## QUALITY ASSURANCE -- NON-CONFORMANCE REPORT

**Report No:** NCR-000532

**Reference Description:** Missed UT Indication by QC, Segment 11BW

**Job Name:** SAS Superstructure

WELD NUMBER: SEG067A-005

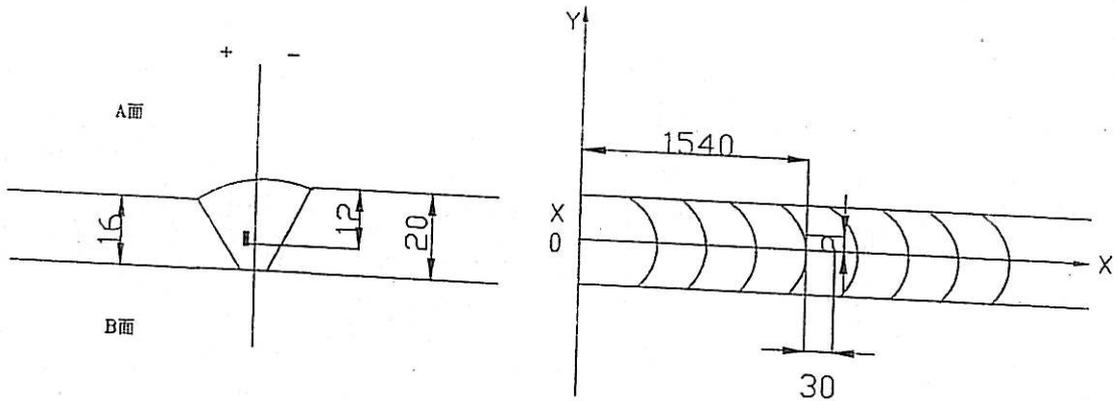
Rejected indication found by ultrasonic inspection is less than the maximum allowance aggregate length.

(UT探伤发现的缺陷总长度小于最大允许长度。) SEG067A-005

1. Did not clear the weld pass completely in time.

1. Gouge or grind from nearer side from metal edge ( $D \leq 0.65T$ , "D" is depth of defects, "T" is thickness of metal) to remove all defects;
2. Follow repair WPS for joint preparation, preheat, and weld deposit;
3. Verify with VT no defects remain in the weld joint prior to welding;
4. Grind the repaired area flush with base metal or the adjacent weld;
5. Check the welds according to the working drawings.
